**APPENDIX M
ECOLOGY MEMORANDUM
ICS Uplands Ecological Risk Analysis
October 9, 2017**

**REMEDIAL INVESTIGATION REPORT
ICS/NWC RI/FS
SEATTLE, WASHINGTON**

ICS Uplands Ecological Risk Analysis

This memorandum represents a Department of Ecology analysis and recommendation regarding the Terrestrial Ecological Evaluation section (Terrestrial Ecologic Contact – Section V (a) (1)) of the document: *Remedial Investigation Report: Industrial Container Services, WA, LLC [Former NW Cooperage Site] Seattle, Washington. Agency Review Draft: September 2016* (DOF, 2016) (Facility Site ID No. 2154).

Appendix A: ICS Site - Exposure Pathways

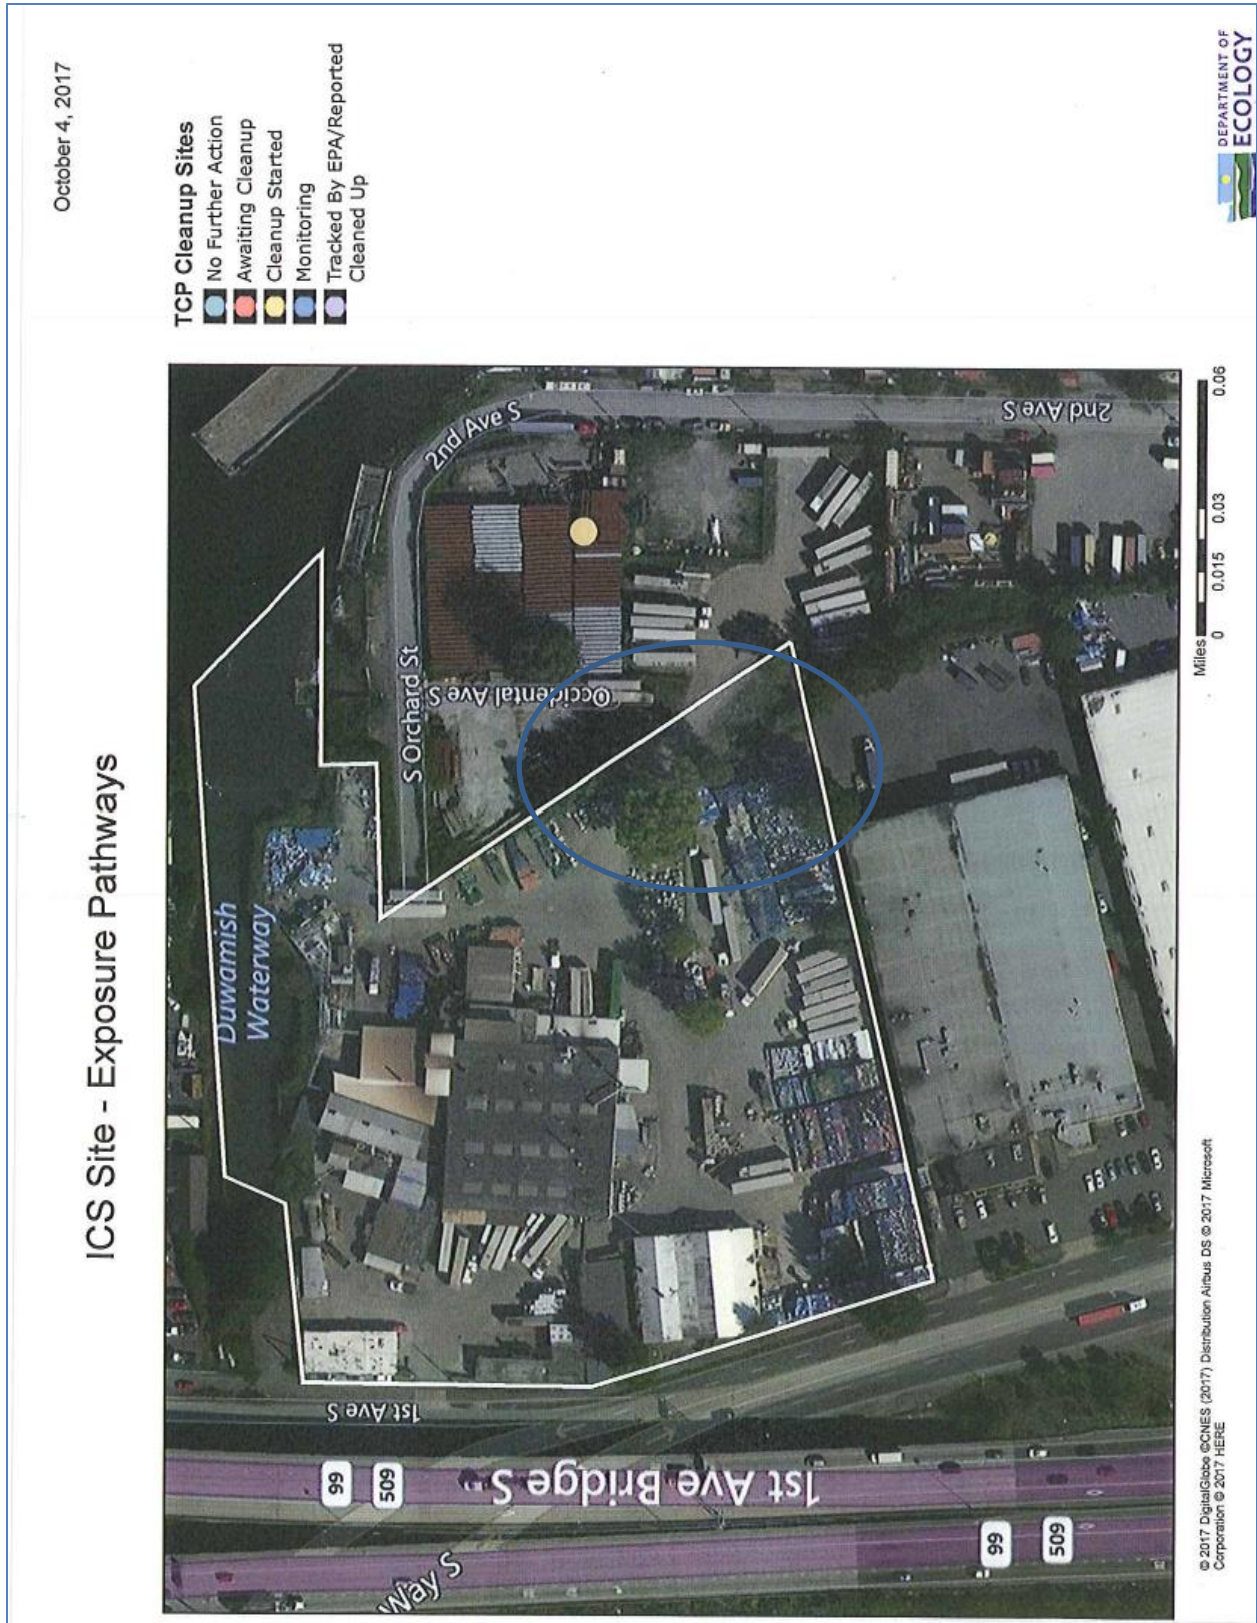
2. **Incomplete exposure pathway (340-7491(1) (b)).** Section V (a) (1) of the Remedial Investigation Report details that *“The Upland Area portion of the Site is zoned industrial and is covered by buildings and paving and satisfies the exclusion criterion in WAC 173-340-7491(1) (b).”* However, it is unclear if this exclusion would apply. It appears there is an undeveloped upland area within the site boundaries. Please see Appendix A (*ICS Site – Exposure Pathways*) and verify that in the lower right hand section of the map (within the site boundaries) there are no hazardous substances detected.

- a. Recommendation: Please verify that there are no hazardous substances detected in the undeveloped area (circled) in Appendix A. If there are hazardous substances detected, the exclusion would not apply and a simplified TEE would be necessary.

Discussion: Please clarify Exclusionary Criteria bullet 2a (above). The site would be excluded from the TEE requirements if the conditions of bullet 2a are met and an institutional control is implemented under WAC 173-340-440. If there are hazardous substances detected in the undeveloped area, a simplified TEE would be necessary.

Appendix B: ICS Site with 500 ft. Buffer

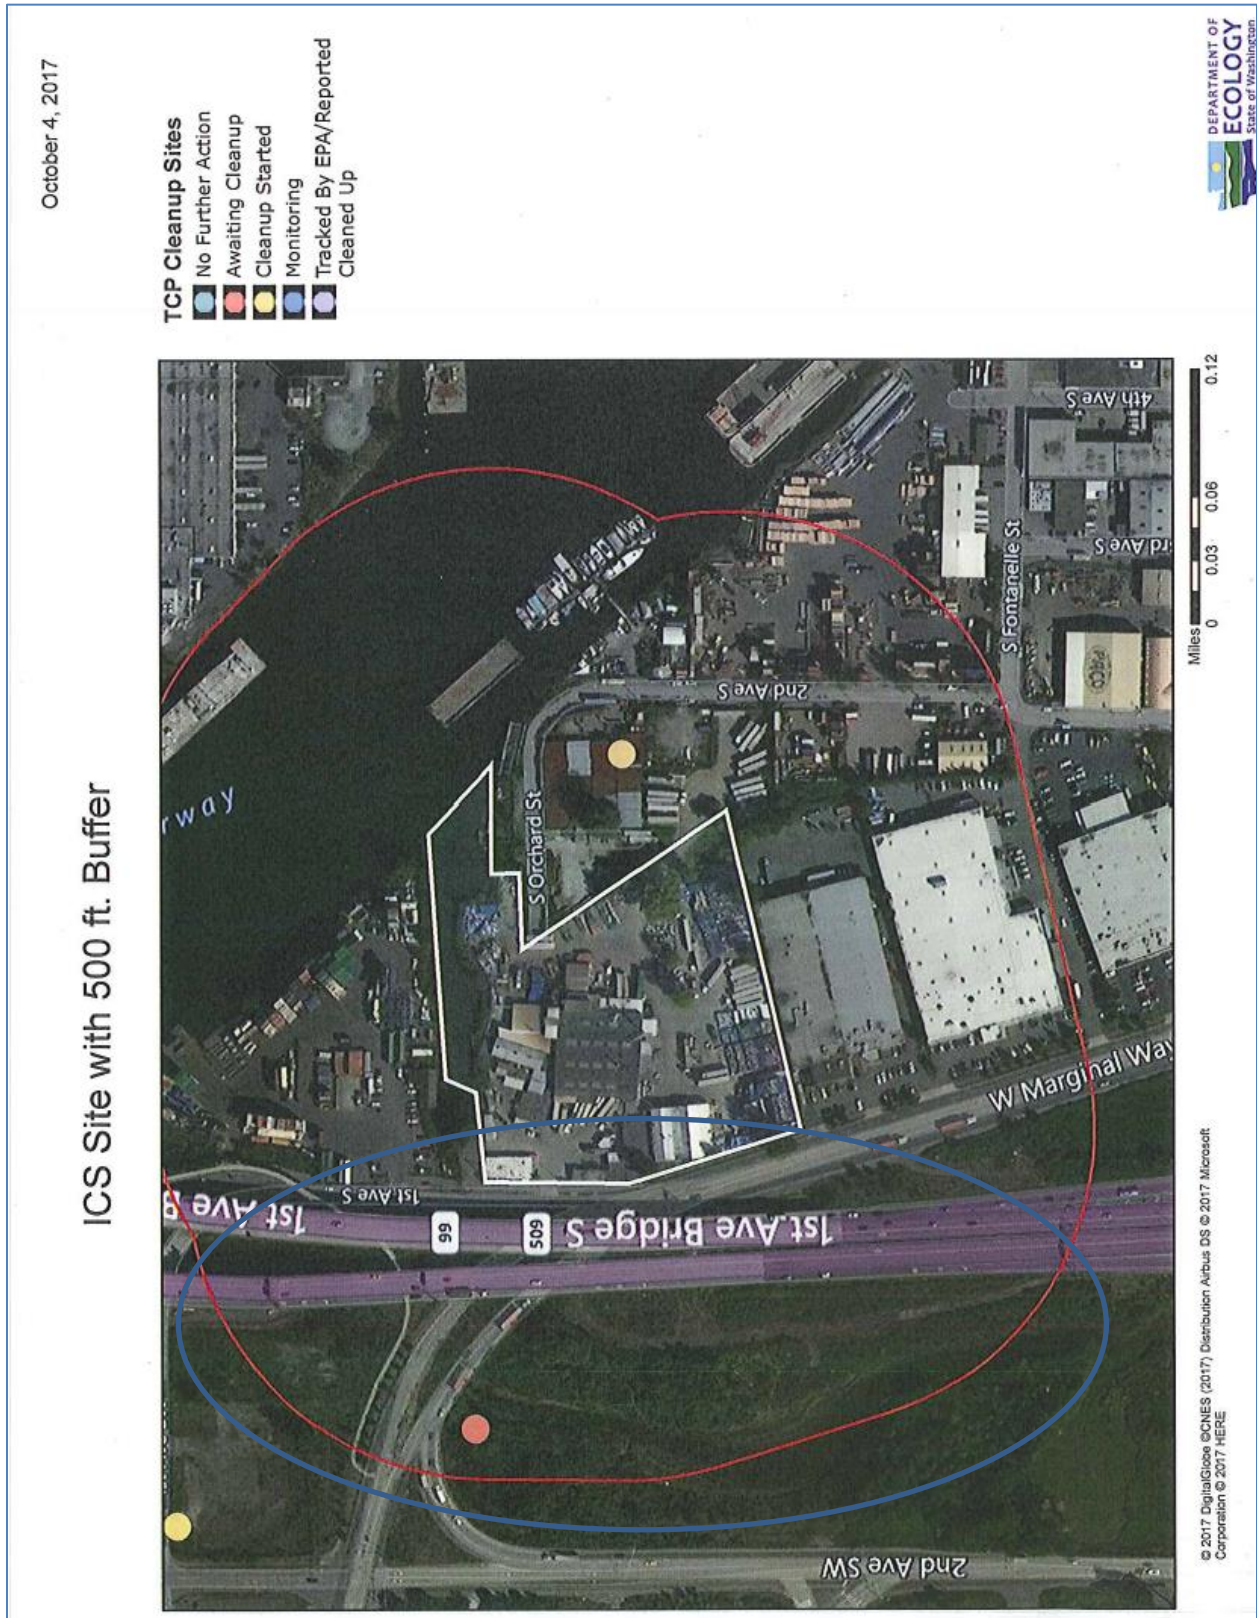
3. **Area of contiguous undeveloped land (340-7491(1) (c)).** This exclusion should not apply. It appears that there is greater than 0.25 acres of contiguous undeveloped land on or within 500 ft of the site, and it also appears hazardous bioaccumulatives are present (i.e. pentachlorophenol, PCB mixtures, etc.). Please see Appendix B (*ICS Site with 500 ft. Buffer - left hand side of the map – West of 509 freeway*).

1. **Management or land use plans maintain or restore native vegetation (340-7491(2) (a) (i)).** It does not appear that this criterion would apply.
2. **Use by threatened or endangered species (340-7491(2) (a) (ii)).** It does not appear that this criterion would apply.
3. **Amount of native vegetation located on the property within 500 ft. of the site (340-7491(2) (a) (iii)).** It does not appear that this criterion would apply. Although there appears to be greater than 10 acres of native vegetation within 500 ft of the site, it is across from the freeway and not located within the property boundaries. Please see Appendix B (*ICS Site with 500 ft. Buffer - left hand side of the map – West of 509 freeway*).
